TRANS/WP.29/GRSP/2001/xx
25 April 2001

Working Party on Passive Safety (GRSP)
(Twenty- ninth session, 7-11 May 2001,
agenda item 3.2)

PROPOSAL FOR DRAFT AMENDMENTS TO REGULATION NO. 17
(Rear Impact collision test procedure)

Transmitted by the Expert from Germany

Figure 1:

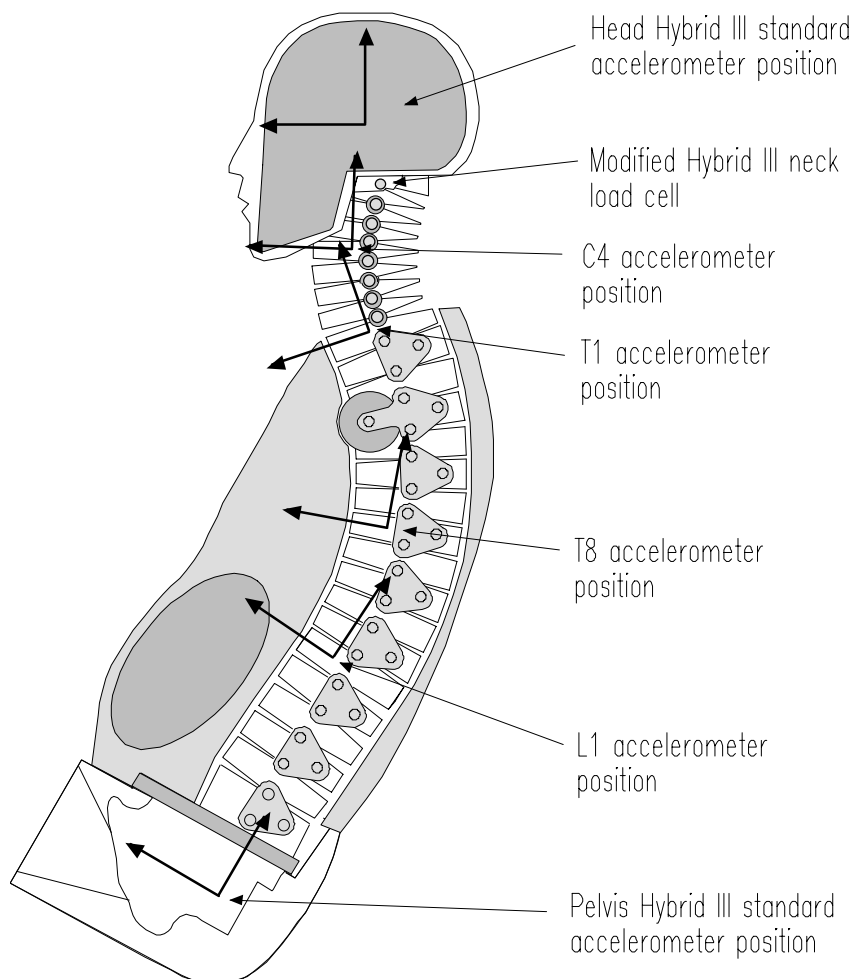
5.16.1.3. The rebound velocity of T1 (the first thoracic vertebra) measured at the time point when, during rebound, T1 reaches the same x-coordinate relative to the sled or car coordinate system it had at $t=0$ or at the time point just before restraint system action sets in, whichever is earlier, shall be equal or less than (2.5 –3.0) m/s.

Drawing of BioRID and position of T1 accelerometer (Overview sketch)

Figure 2:

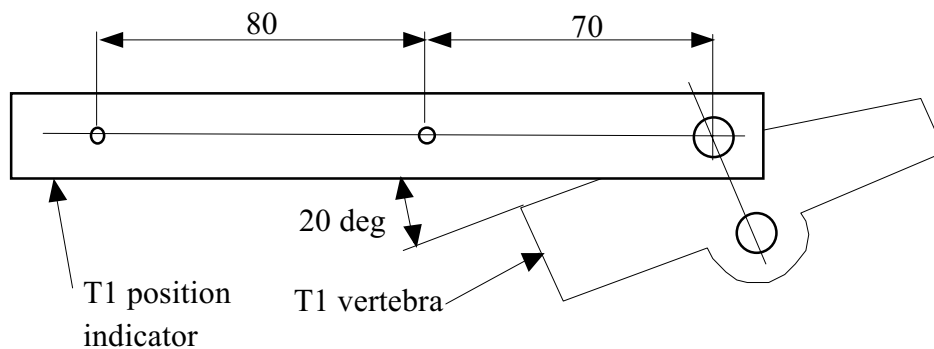
Bar for special film targets

The above shown bar shall be fitted in addition at the T1-vertebra. Both holes are prepared 70 and 80 mm apart to provide locations for special film targets. The hole on the right side is provided for the fitting of an additional accelerometer. The x- axis of the additional accelerometer shall be parallel to the bar i.e. 20° in relation to the position of the first T1 accelerometer.

Figure 2: Deceleration/acceleration pulse- corridor

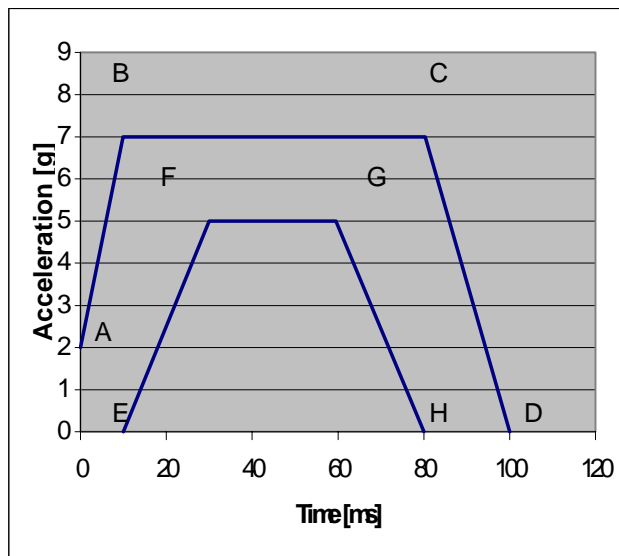
5.3. Active devices

Time [ms]	Point	a [g]	Time [ms]	Point	a [g]
0	A	2	10	E	0
10	B	7	30	F	5
80	C	7	60	G	5
100	D	0	80	H	0
